PHASE I INSPECTION REPORT

*Stevens Lake Dam (VA-12509), James River Basin,  
Nelson County, State of Virginia.*

PREPARED FOR  
NORFOLK DISTRICT CORPS OF ENGINEERS  
803 FRONT STREET  
NORFOLK, VIRGINIA 23510

PREPARED BY  
MICHAEL BAKER, JR., INC.  
BEAVER, PENNSYLVANIA 15009

STEVENS LAKE DAM  
SKETCH OF PRINCIPAL SPILLWAY INTAKE  
SCALE: 1 INCH = 1 FOOT

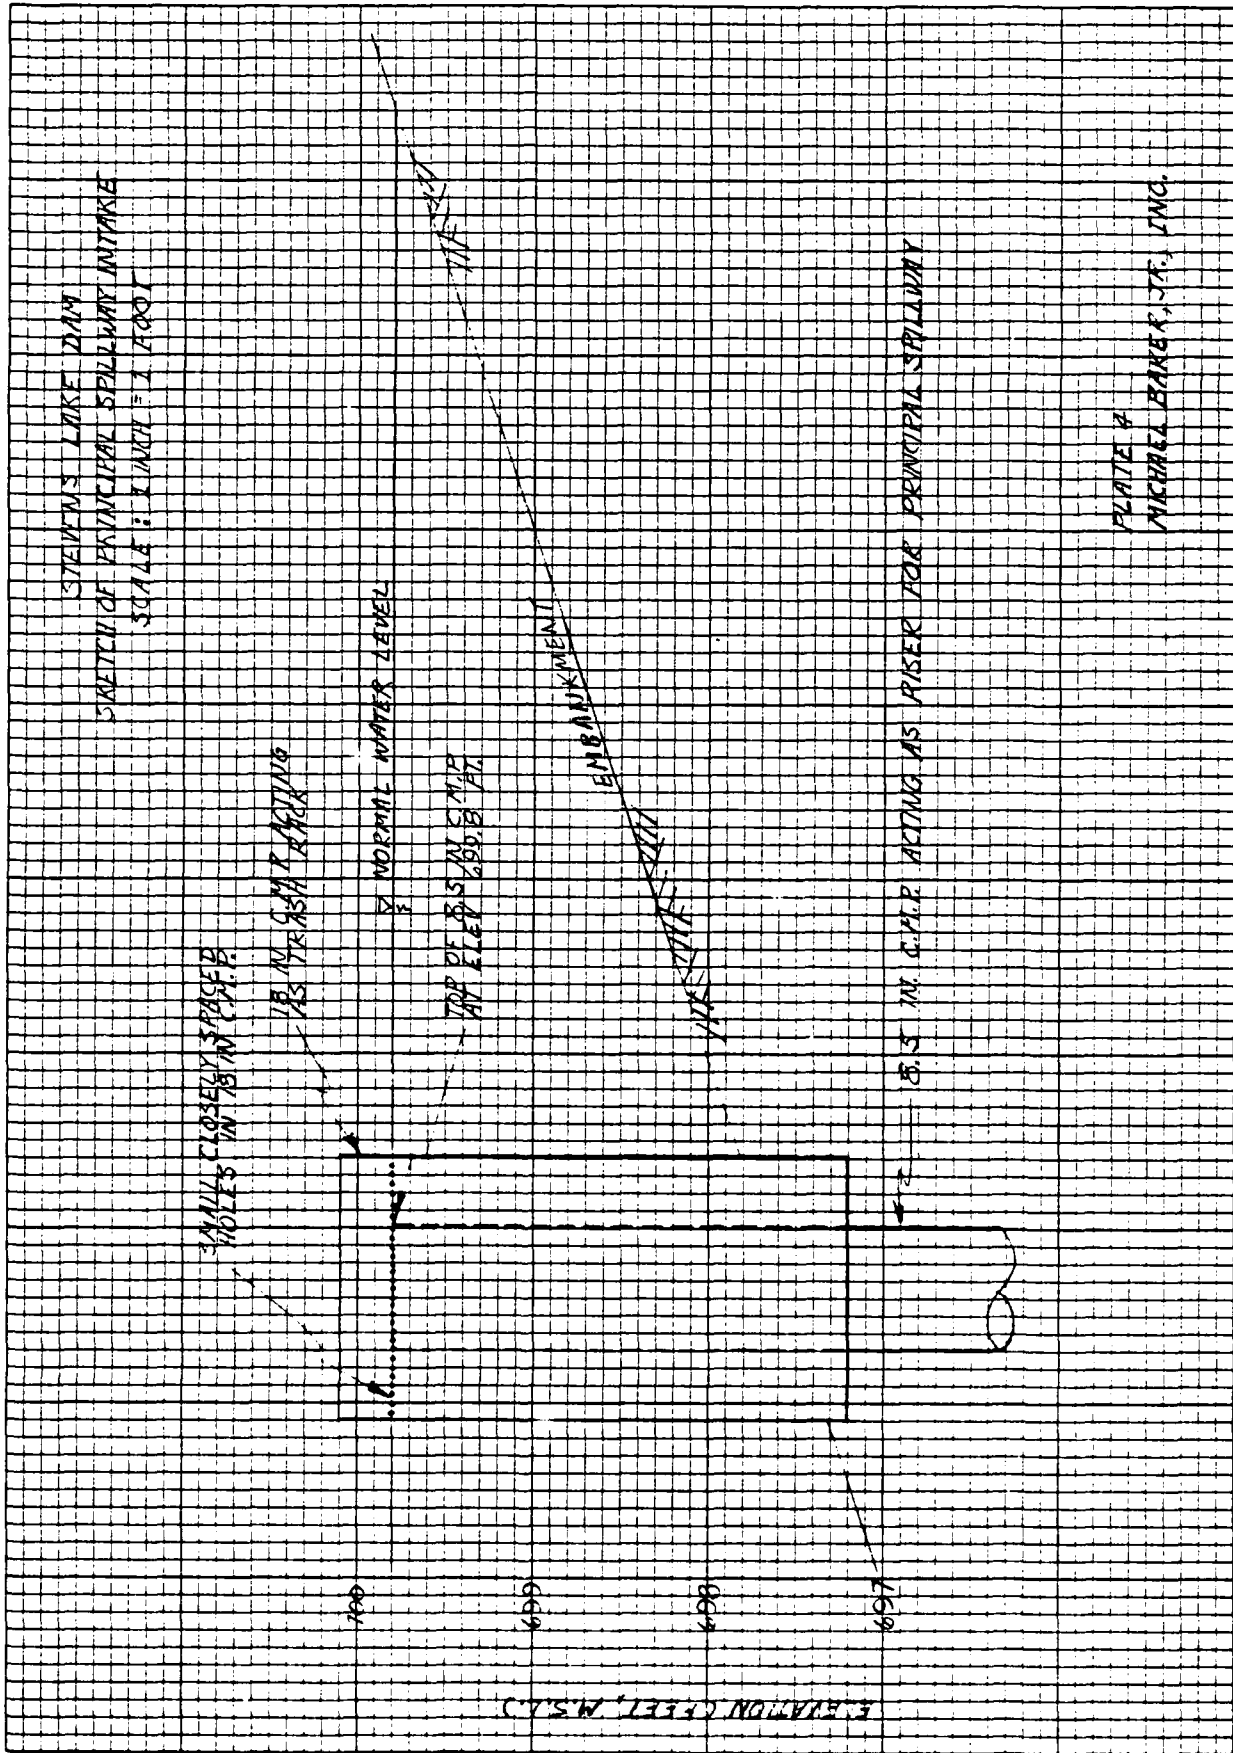
serving as a trash rack at low flows (see Appendix I, Plate 4). At 699.8 feet M.S.L., which is the elevation of the top of the 8.5 inch riser, the 18 inch pipe has a row of closely spaced very small holes extending completely around its circumference. The top of the 18 inch pipe is at elevation 700.1 feet M.S.L. The 8.5 inch diameter outlet pipe for the principal spillway is approximately 135 feet long and discharges into a natural channel at the toe of the embankment.

- 3.1.3 Appurtenant Structures: The principal spillway intake structure is a vertical 8.5 inch diameter corrugated metal pipe surrounded by a vertical 18 inch diameter corrugated metal pipe acting as a trash rack. A ring of small holes perforate the trash rack 4 inches below the top. At the time of the inspection, the holes were partially clogged with weeds. The outlet pipe is of heavy gage and its original coating of bituminous is almost entirely worn away. The end of the pipe is flanged. The outlet conduit protrudes directly from the toe of the embankment with no visible supporting structure. The discharge falls approximately 2 feet into a natural channel. There are no facilities for dewatering the reservoir.

- 2) Clear the trash rack on the principal spillway.
- 3) Fill, regrade, and seed all areas where erosion has occurred.
- 4) Remove the scattered small trees from the emergency spillway. Consideration should also be given to moving the barbed wire fence further downstream where its tendency to catch debris will not restrict flows.
- 5) Install a staff gage to monitor reservoir levels above normal pool.
